**CENTER FOR DRUG EVALUATION AND
RESEARCH**

202158Orig1s000

OFFICE OF DEVICE EVALUATIONDIVISION OF ANESTHESIOLOGY, GENERAL HOSPITAL,
RESPIRATORY, INFECTION CONTROL, AND DENTAL DEVICES**GENERAL HOSPITAL DEVICES BRANCH
INTERCENTER CONSULT MEMORANDUM**

1. Submission Overview

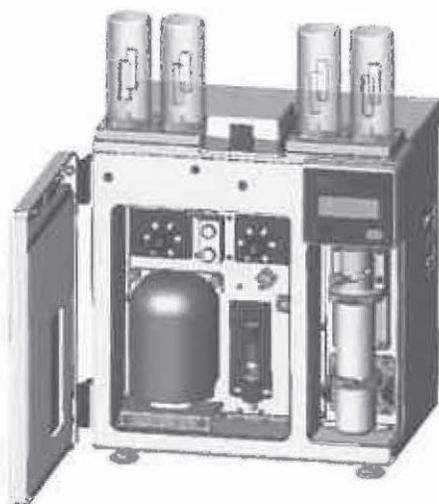
1. **Lack of flow or pressure sensors:** The flow circuit in the system is very complicated with same tubing lines used multiple times for transporting the source solution, cleaning agents, and the final Tc99 product (Figure 1). Any leaks/blockage in the fluid lines could adversely impact the safety and efficacy of the instrument. Consequently, constant monitoring of the flow circuit is critical to avoid any fluid leaks and to ensure proper functioning of the valves. After reviewing the NDA submission, it was not clear if the TechnGen instrument hosts any sensors to measure flow or pressure in the fluid lines. In pages 141 (4.12) and 162 (4.2.17) of the Drug Master File (DMF 26592), the sponsors had stated that " (b) (4)

2. Kinking of tubes: One of the major safety/efficacy concerns during the operation of the TechneGen instrument is the possibility of partial or complete occlusion of flow lines due to kinking of tubes. This risk is very relevant for tubing lines that are exposed outside the instrument (Figure 2). When the sponsors came to the FDA to demonstrate their device, the FDA reviewers got a chance to check the type of tubing used for the fluid lines and found them to be susceptible to kinks. Fully or partially occluded tubing could adversely affect the quality of the final product and pose safety risk to the operator. To mitigate this risk, the sponsors are proposing to (b) (4) (b) (4) shown in Figure 2). The sponsors claim that the (b) (4) will minimize/eliminate the risk of kinking. We have requested the sponsor to provide evidence that the kinking problem disappeared after (b) (4)

It should also be noted that the sponsors are not proposing to (b) (4) tubing inside the instrument (Figure 1). Since the same type of tubing is used inside the device, kinking could still be a potential long-term issue. Consequently, we have requested Northstar to deliberately kink the tubing at key locations (such as near valves and connectors), and observe if the product quality is affected due to the reduction in the flow rate. **The Agency is awaiting the applicant's response.**
